4215 Holly Lane – Drainage Issues Response

From: Alex Lupulyak, PE
To: Marlon Nerio, F & M Construction and Remodeling
Subject: 4215 Holly Lane Drainage Issues Response

Subject: File No. 2510-181

Figure 2: Approximate Drainage Path

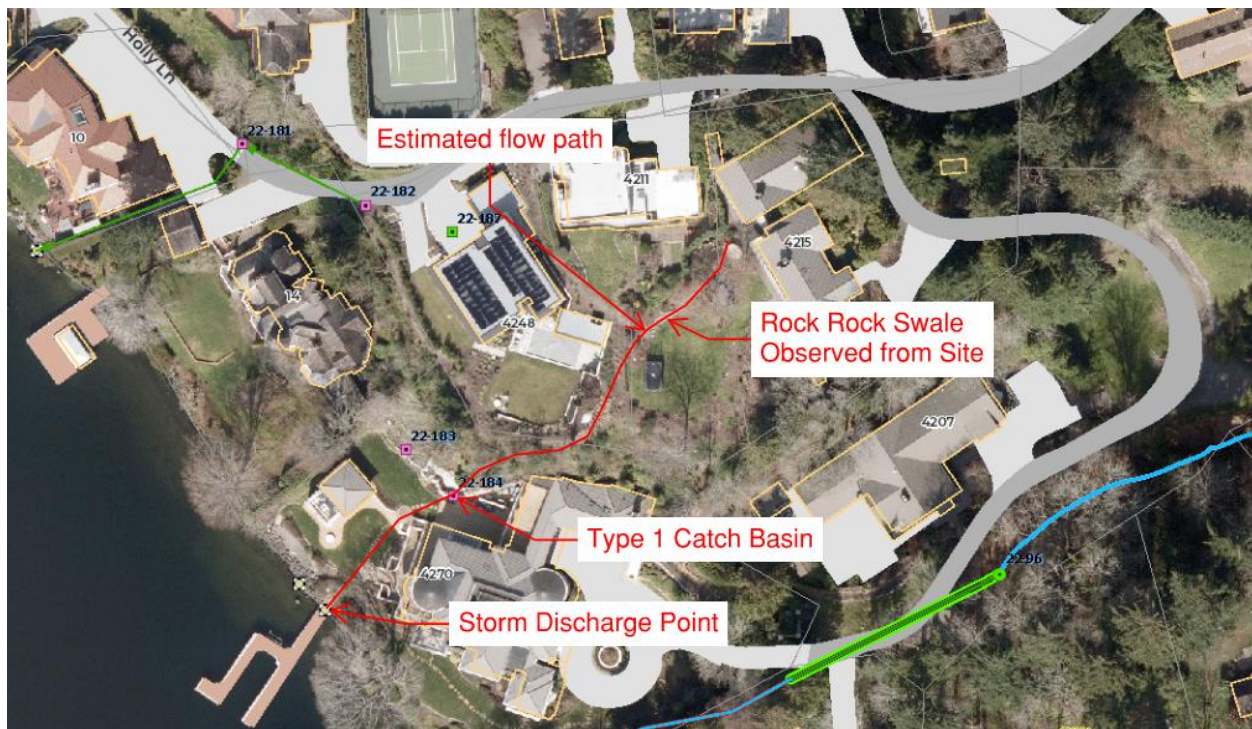
We received a Public Notice of Application for 4215 Holly Lane File No:2510-181 and have only one concern which regards storm water management.

We live at the bottom of Holly Lane at #14. When the house immediately to the east of us at #4248 was recently built, it was found that an old storm water drainage for that property went into our steep backyard and was broken. There used to be access to that line but now that is no longer the case. The residents at #4248 moved their storm water drainage to a more accessible point on Holly Lane.

We fear, but don't know for certain, that the stormwater drainage for #4215 is also connected to the old broken drainage pipe on the south side of our property and therefore should also be moved to an existing, accessible and maintainable location. As you are probably aware this part of Holly Lane is steep and subject to sliding as happened at #4247 Holly Lane some time ago.

In addition to no net increase of impervious surfaces, the approximate drainage path from the project site can be seen below in **Figure 2**. The area downstream of the project is private property and HRC does not have permission to enter, so the flow path is no guarantee, but is believed to be accurate based off of observation from the project site made by HRC in the field and City of Mercer Island GIS data.

Runoff from the project site #4215 exits the site on the western portion into a rock swale through #4211 (visibly from the project site), through #4248, and is believed to enter a Type 1 Catch Basin on site #4270, and discharged to Lake Washington where the Storm Discharge Point is visible on the GIS.

With no net increase in impervious surfaces, no increase in stormwater runoff, and the estimated flow path, we believe the project will have not increase any

adverse impacts on the existing stormwater system that did not exist prior to this project.
